EPC STORMWATER REVIEW COMMENTS
IN ORANGE BOXES WITH BLACK TEXT

GRADING AND EROSION CONTROL PLANS

THE COMMONS AT FALCON FIELD - FILING NO. 1

EPC FILE NO.: SF2435

OVERALL EROSION CONTROL PLAN

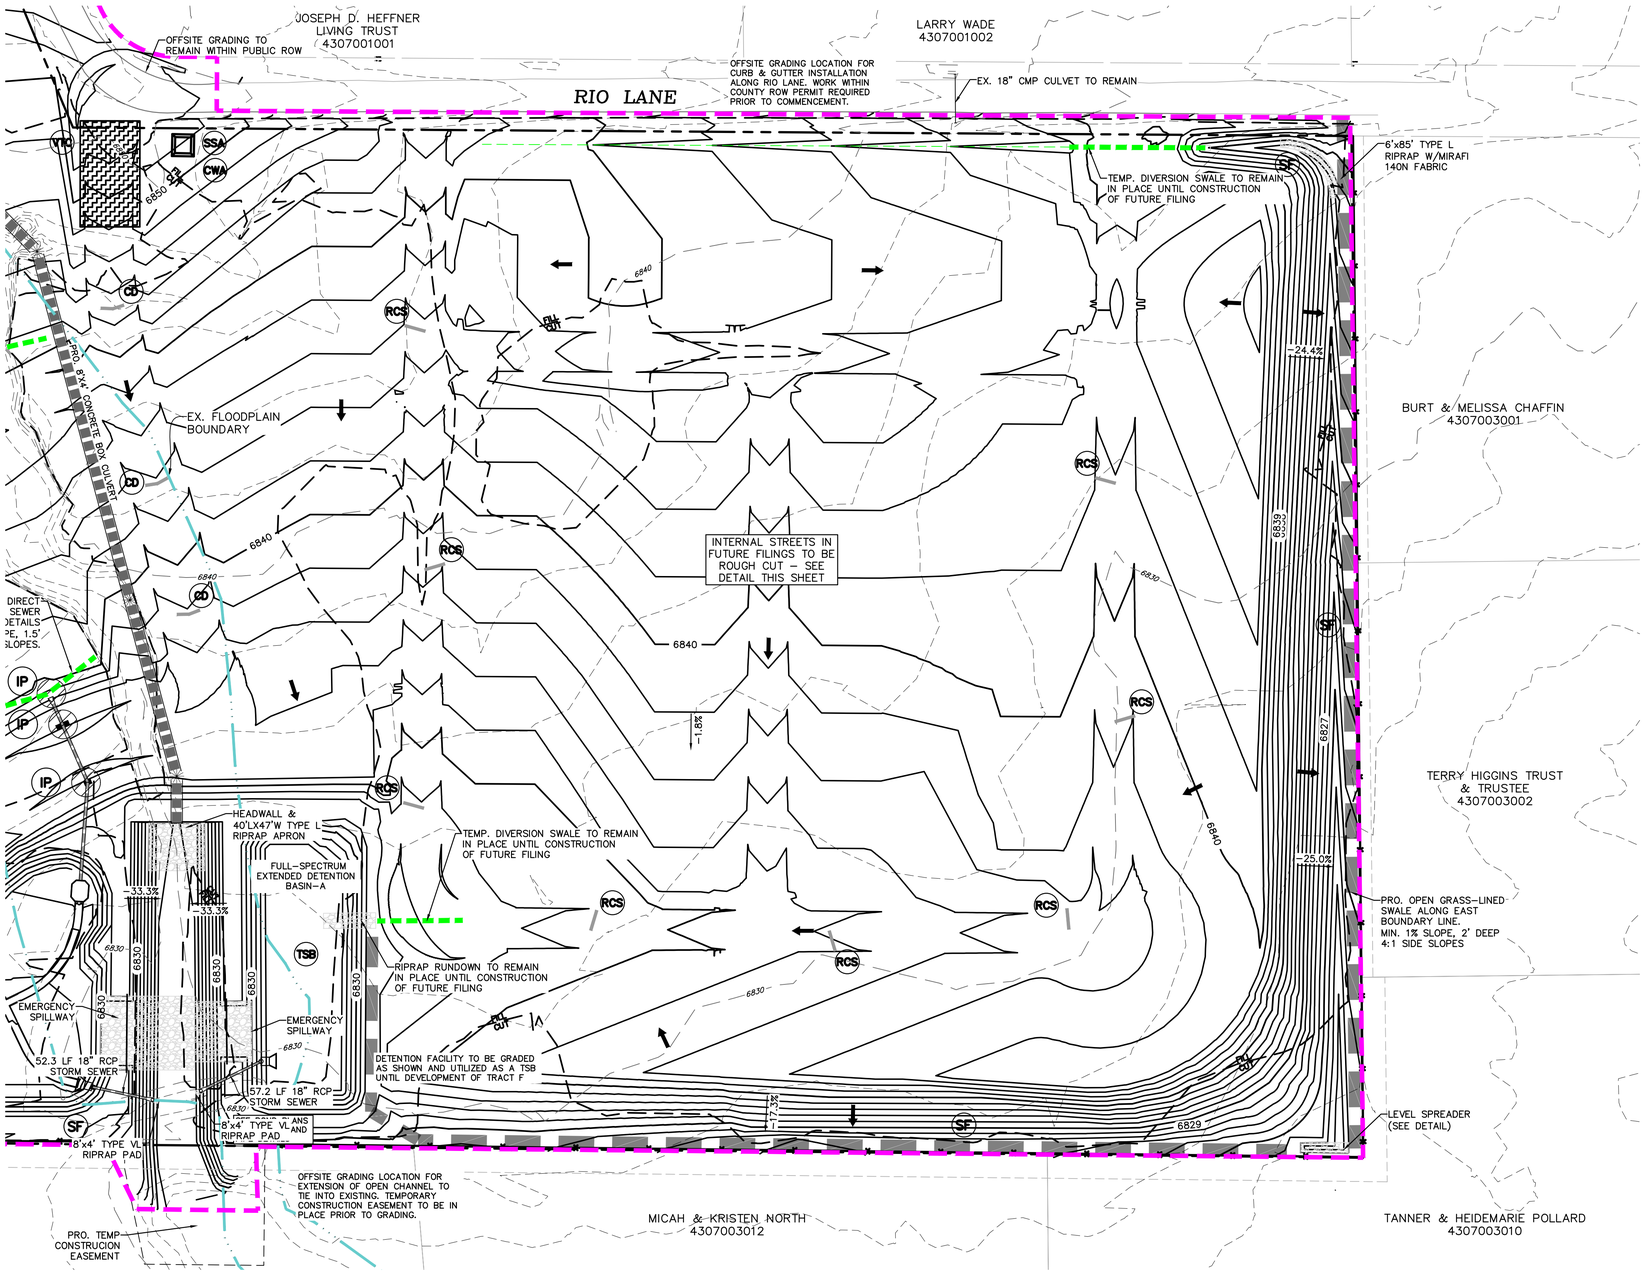
GEC Checklist Item V - Show dewatering operations as anticipated at time of design. The contractor can work with the County to adjust dewatering but the locations of the pumps and planned discharges should be shown as anticipated.

POND LINER DETAILS

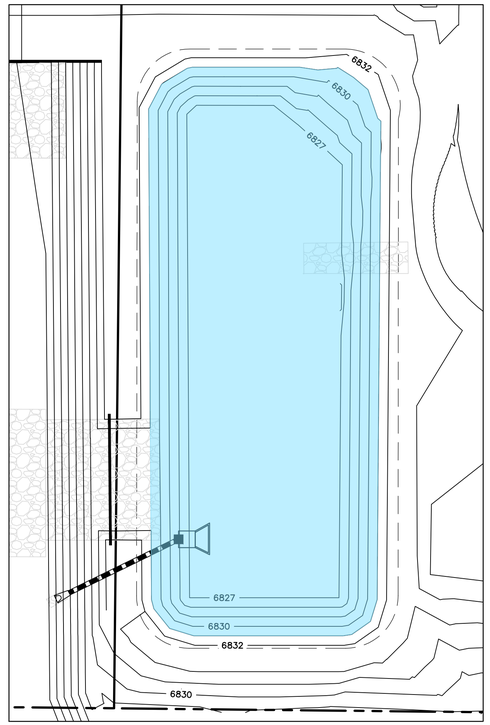
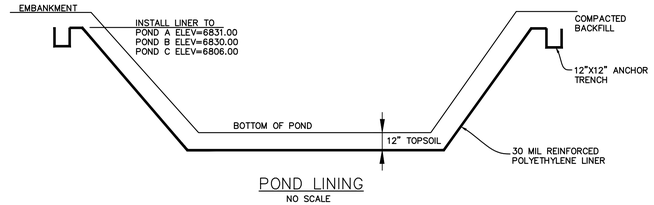
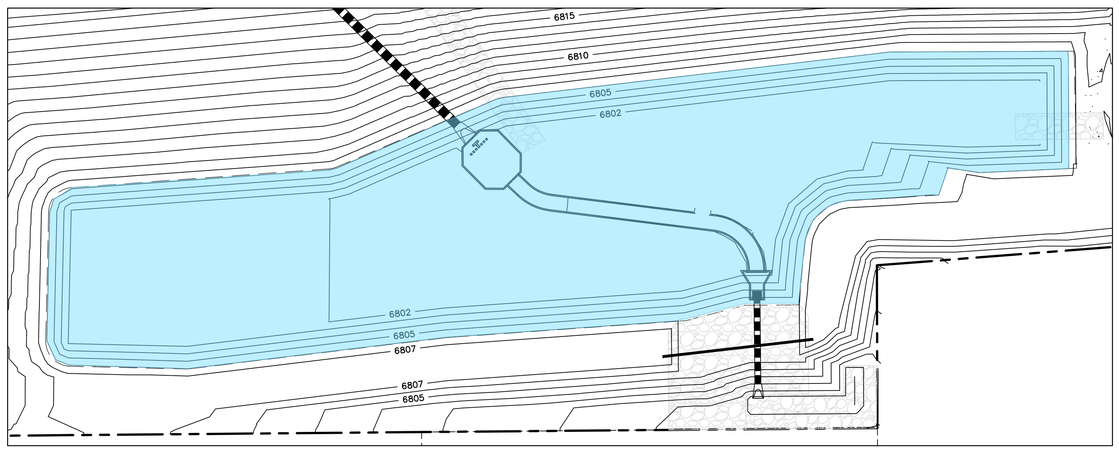
There has been no data provided to support the groundwater reducing by 4' from the existing condition. A liner will be required regardless of if groundwater is present at time of excavation. Remove this statement.

~~IF GROUNDWATER IS PRESENT WITHIN 4' OF THE POND BOTTOM A POND LINER WILL BE REQUIRED.~~

Add a note specifying that the liner shall extend under the concrete components ie trickle channel, forebay, micropool, etc

TRACT E (FUTURE FILING 3) EAST SWALE – LEVEL SPREADER

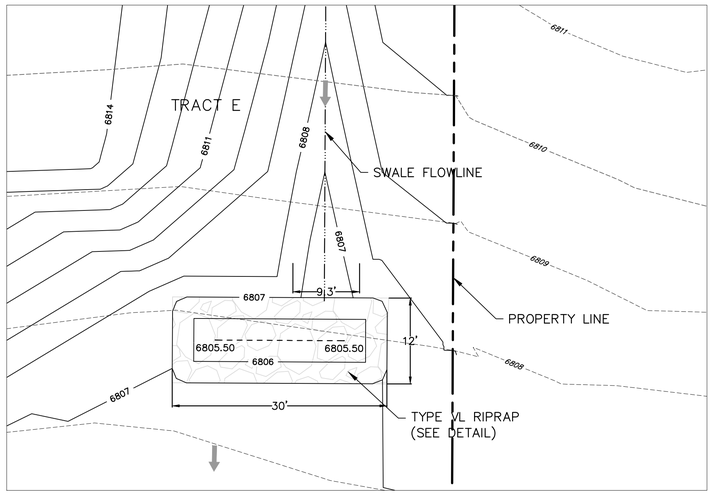
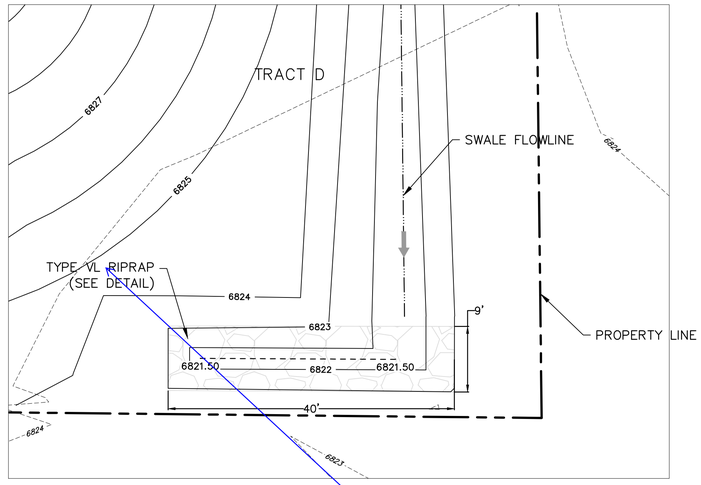
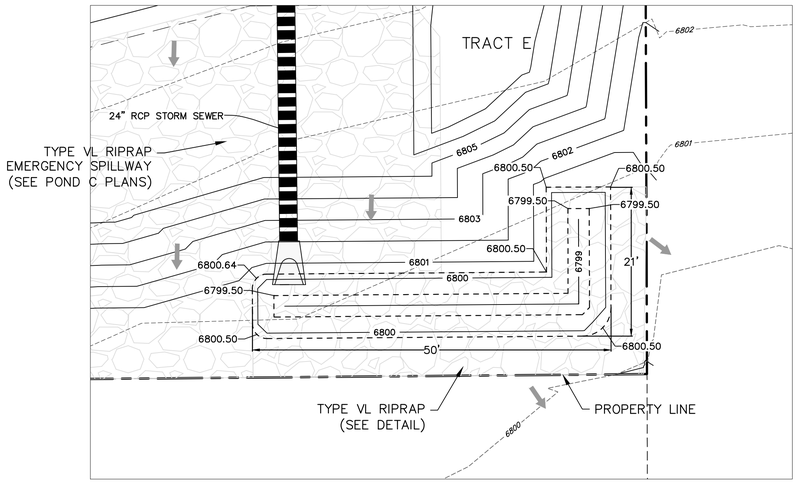
The plan views indicate VL yet the detail indicates type L
